**KNOXVILLE HISTORIC ZONING COMMISSION
STAFF REPORT - CERTIFICATE OF APPROPRIATENESS APPLICATION**

PROPERTY ADDRESS: 26 Market Sq 37902

FILE NO.: 10-D-18-HZ

LEVEL OF WORK: Level II. Major addition of materials or architectural elements

RAILING TO MATCH EXISTING RAILING AT 28 MARKET SQUARE

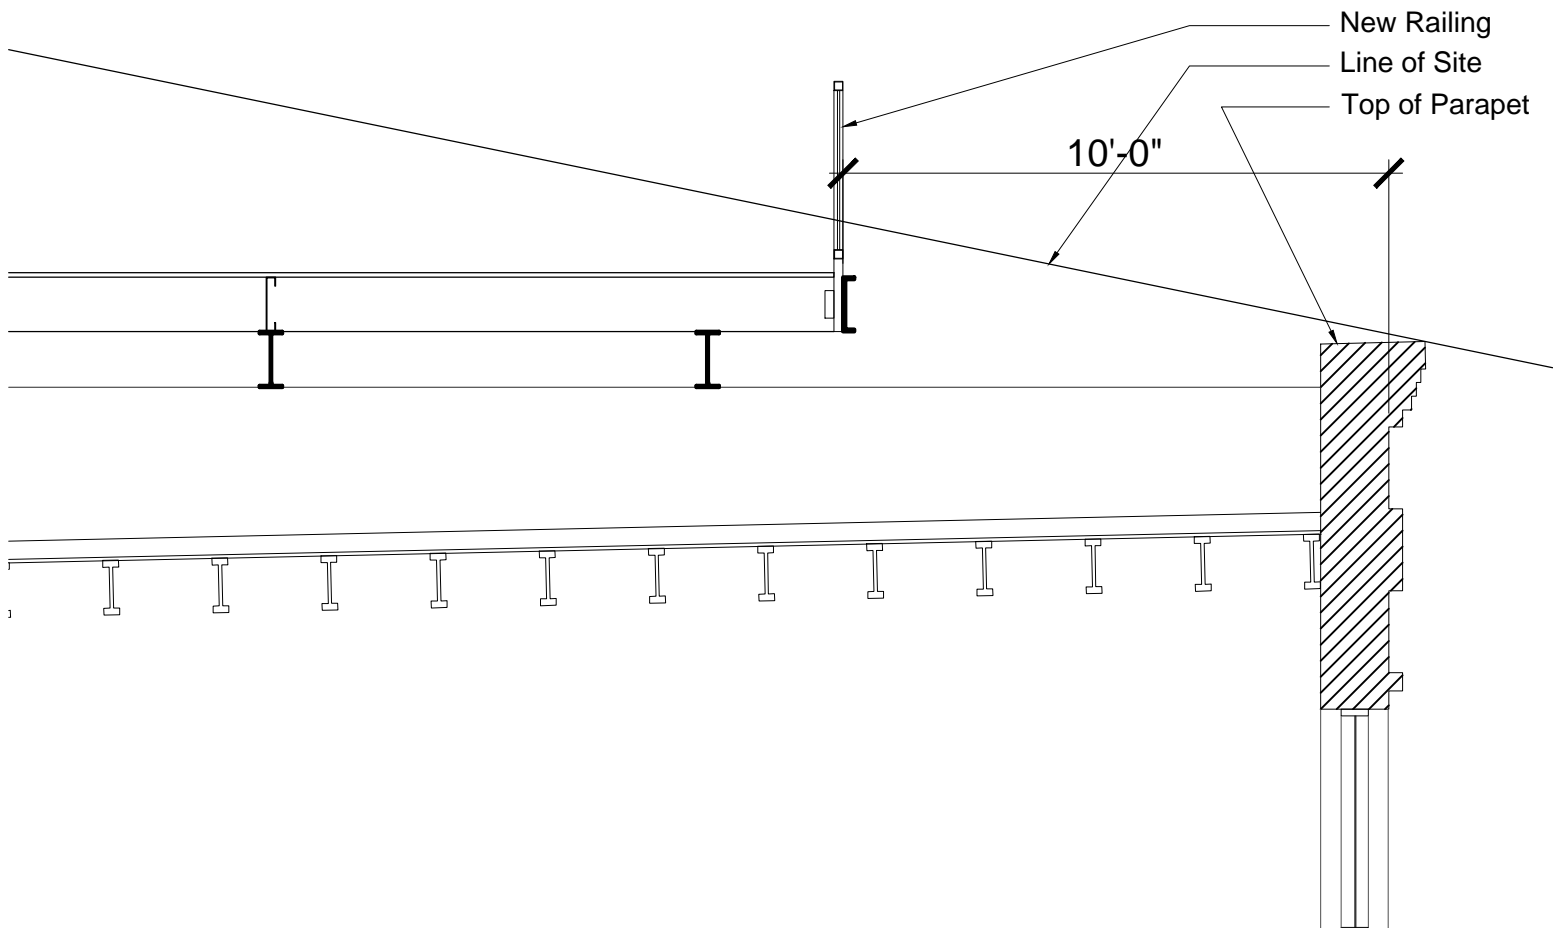
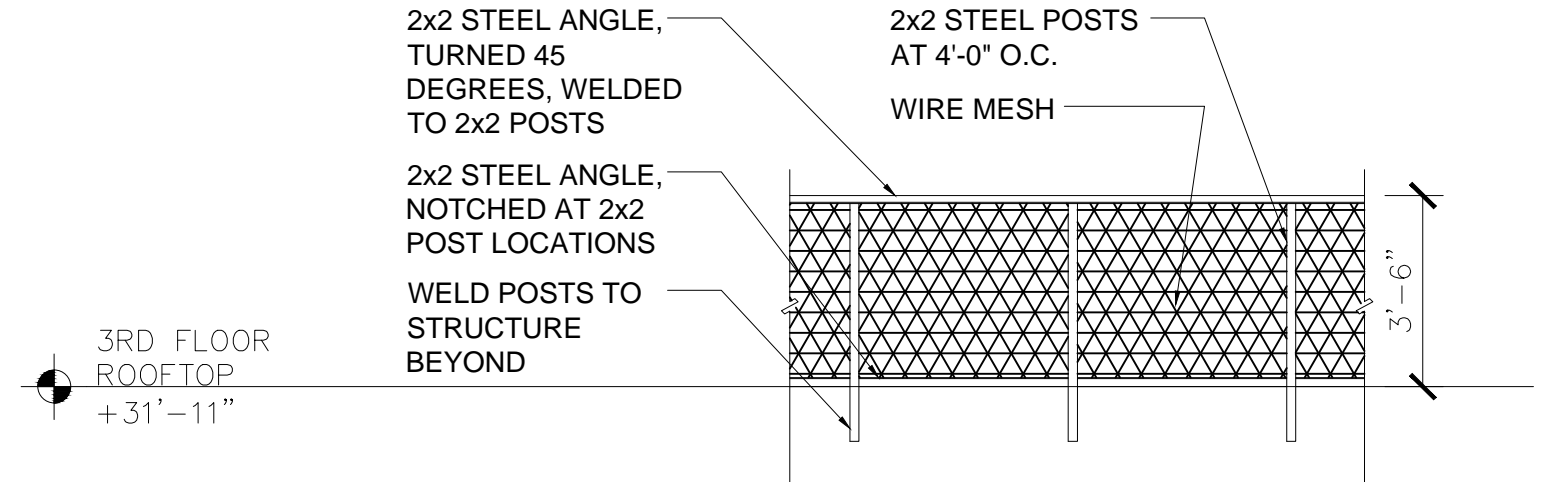
- 6) The proposed mesh material is practically opaque as opposed to the type of guardrails previously approved on rooftops in Market Square, and would therefore be more obtrusive.

- 7) The proposed guard rail is to match that at the adjacent north 28 Market Square. The appearance of the guardrail for 28 Market Square was not specifically reviewed by the HZC since was not approved to be visible from Market Square.

- 1) that the guard railing for 26 Market Square be set at a distance back from the front roof edge so as not to be visible at any distance from within the Market Square public way when the roof edge is viewed from directly in front of the building; and
- 2) that the material and/or design be as low profile and as transparent as the previously approved roof guard rails within Market Square.
